RELEASE FOR
CONSTRUCTION
AS NOTED ON PLANS REVIEW
DEVELOPMENT SERVICES
LEE'S SUMMIT, MISSOURI
03/05/2021

IQ BUILDERS	PLAN #HQ-5209 ELEVATIONS	1/4"=1' 0"
	RESIDENTIAL PLANS BY JIM SKINNER (913)268-3164	© Copyright 2016 Jim Skinner — 11-21-16

IQ BUILDERS
LOT 725 EAGLE CREEK
2338 SW OLD PORT RD, LEE'S SUMMIT, MO
STRUCTURAL DETAILS & NOTES

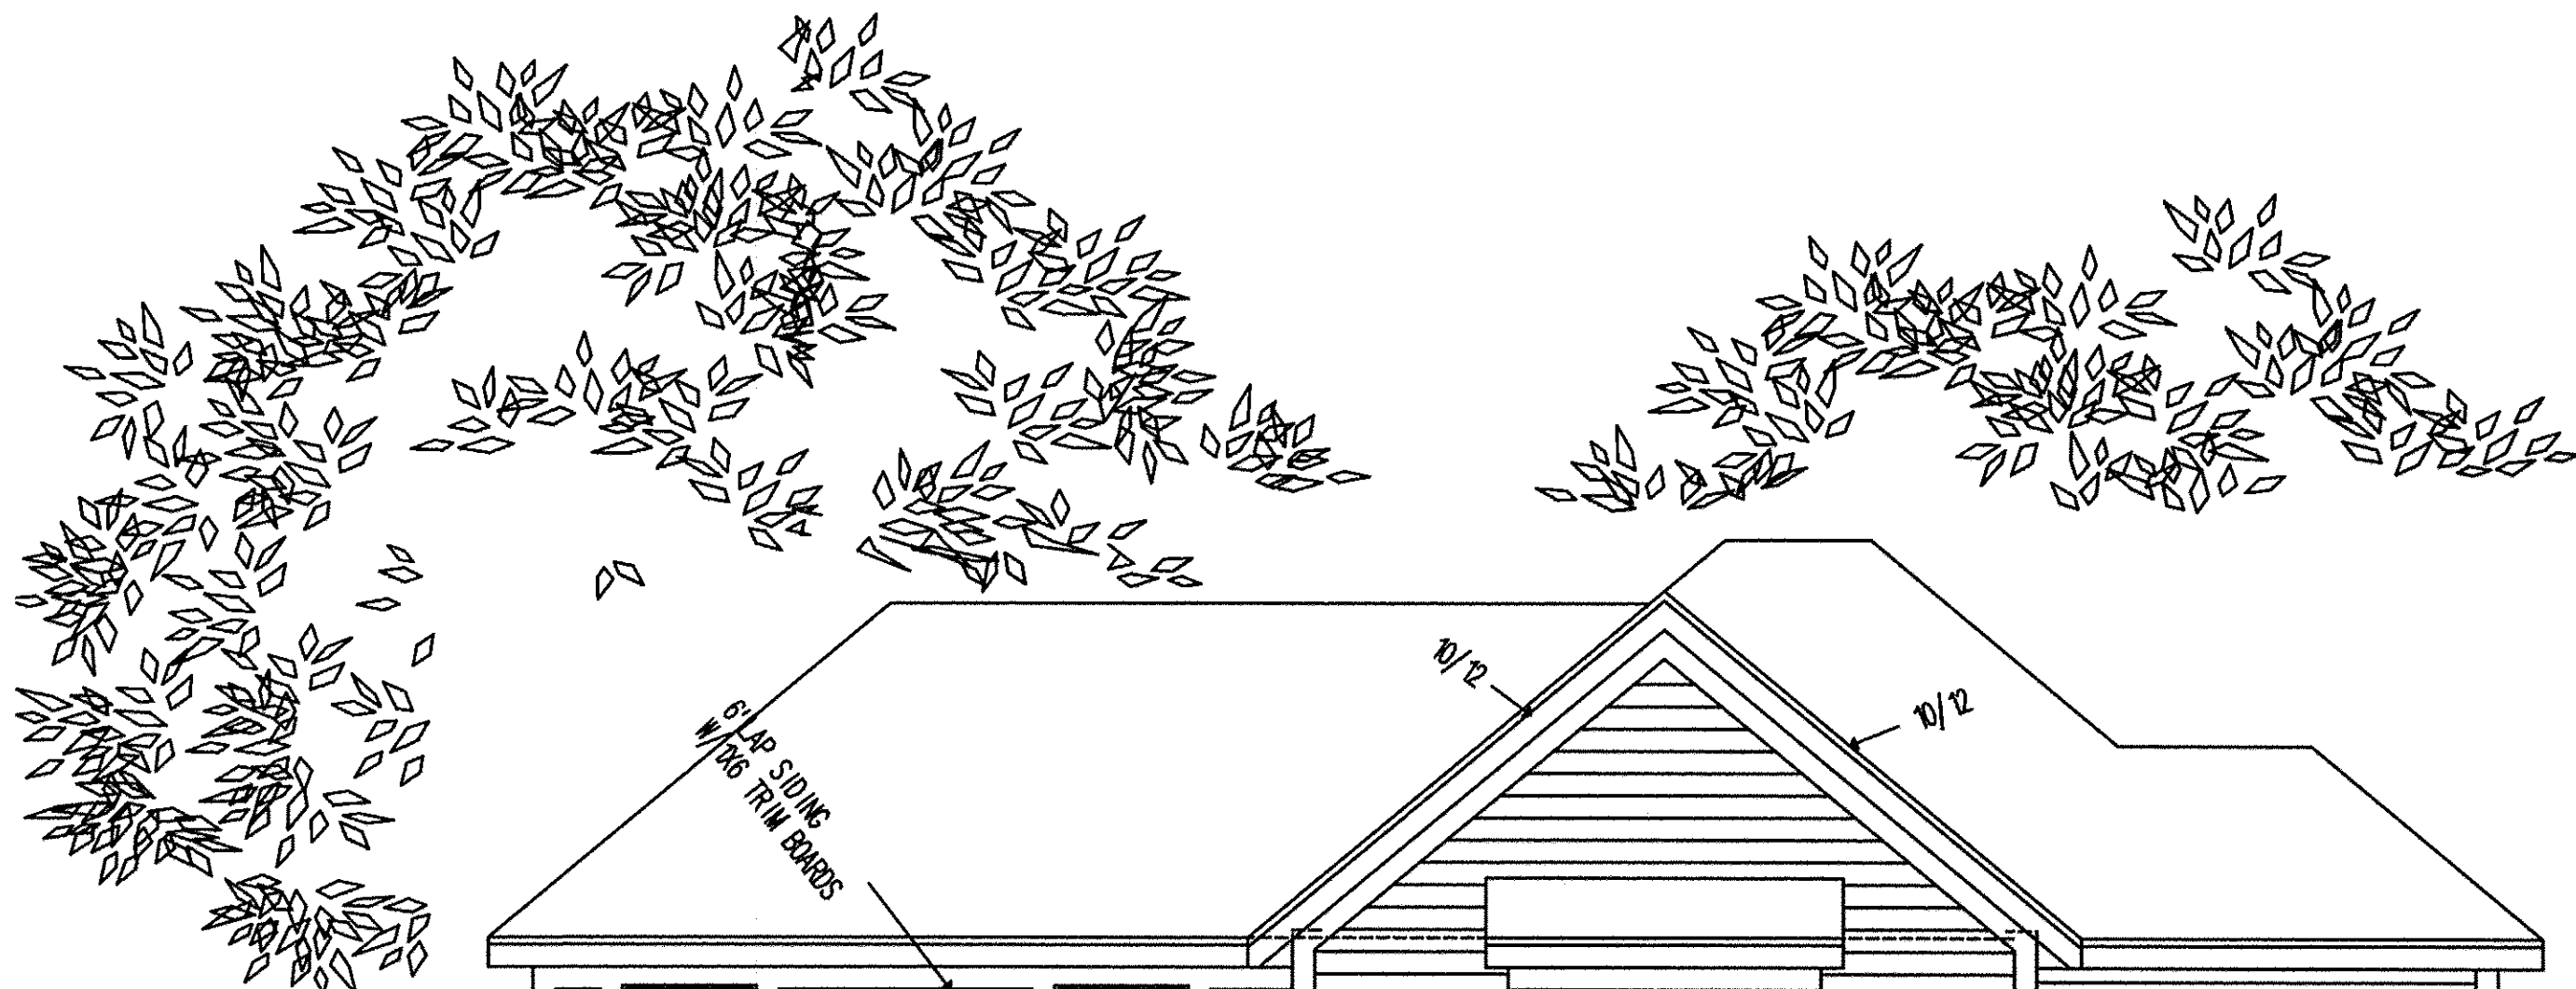
ADJUST ROOF TO WINDOW TRIM
